Re: Quaker Bridge Road Bridge Replacement Project
Request for Waiver of Wetland Activity Permit Application Fee

QUAKER BRIDGE ROAD BRIDGE REPLACEMENT
Wetland Activity Permit Renewal Narrative
Village of Croton-on-Hudson Permit No. 20250002

REPLACEMENT OF QUAKER BRIDGE ROAD BRIDGE
OVER CROTON RIVER (BIN 3348560)
TOWN OF CORTLANDT, NEW YORK
LANDSCAPE PLAN

LANDSCAPING NOTES

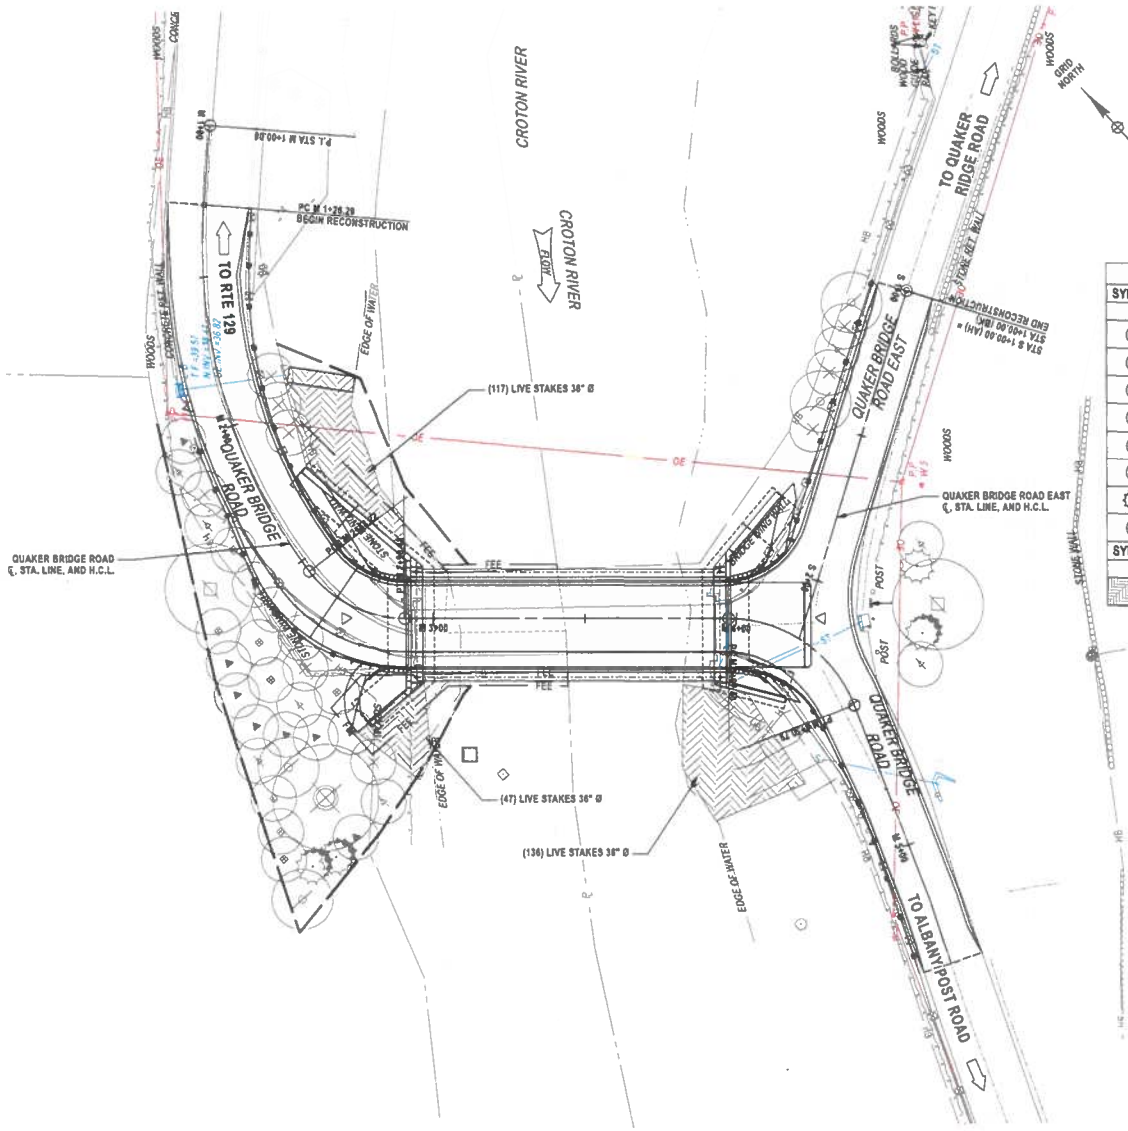
NYDOT ITEM NUMBER	DESCRIPTION	QUANTITY	UNIT
LANDSCAPING:			
611.8114	PLANTING - MAJOR DECIDUOUS TREES - 8' HEIGHT, 2-3" CALIPER	~~75~~ 117	EA
611.19	POST-PLANTING CARE	~~75~~ 117	EA
610.08000024	LIVE STAKE PLANTINGS 1" TO 2"	300	EA
610.1401	TOPSOIL - REUSE ON-SITE MATERIALS	90	CY
610.1101	MULCH FOR PLANTING TYPE A,B & D WOOD CHIPS & SHREDDED BARK	90	CY
610.19	WATERING VEGETATION	0.225	1000 GAL

SYMBOL	CODE	QTY	BOTANICAL/COMMON NAME	CONTAINER	SPACING	REMARKS
			TREES			
	AS	~~17~~ 29	ACER SACCHARUM/SUGAR MAPLE	2" CAL. MIN.		6-8' MINIMUM HEIGHT ONCE PLANTED
	BL	~~11~~ 16	BETULA LENTA/SWEET BIRCH	2" CAL. MIN.		6-8' MINIMUM HEIGHT ONCE PLANTED
	FA	4 ~~4~~ 9	FRAXINUS AMERICANA/WHITE ASH	2" CAL. MIN.		6-8' MINIMUM HEIGHT ONCE PLANTED
	LT	~~11~~ 17	LIRIODENDRON TULIPIFERA/TULIP POPLAR	2" CAL. MIN.		6-8' MINIMUM HEIGHT ONCE PLANTED
	PO	4 ~~4~~ 9	PLATANUS OCCIDENTALIS/AMERICAN SYCAMORE	2" CAL. MIN.		6-8' MINIMUM HEIGHT ONCE PLANTED
	QR	~~15~~ 20	QUERCUS RUBRA/NORTHERN RED OAK	2" CAL. MIN.		6-8' MINIMUM HEIGHT ONCE PLANTED
	TC	5 ~~5~~ 10	TSUGA CANADENSIS/EASTERN HEMLOCK	2" CAL. MIN.		6-8' MINIMUM HEIGHT ONCE PLANTED
	UA	8 ~~8~~ 16	ULMUS AMERICANA/AMERICAN ELM	2" CAL. MIN.		6-8' MINIMUM HEIGHT ONCE PLANTED
SYMBOL	CODE	QTY	BOTANICAL/COMMON NAME	CONTAINER	SPACING	REMARKS
			SHRUB AREAS			
	SN	300	SALIX NIGRA/LIVE STAKES	1" MIN. CAL. LIVE STAKE	36" O.C.	1-2" DIAMETER, 2-6' LONG DEPENDING ON SITE APPLICATION

REVISION NUMBER	DATE	MADE BY	APP'D BY	REVISION
1	7/18/25	KSE		QUANTITY REVISIONS
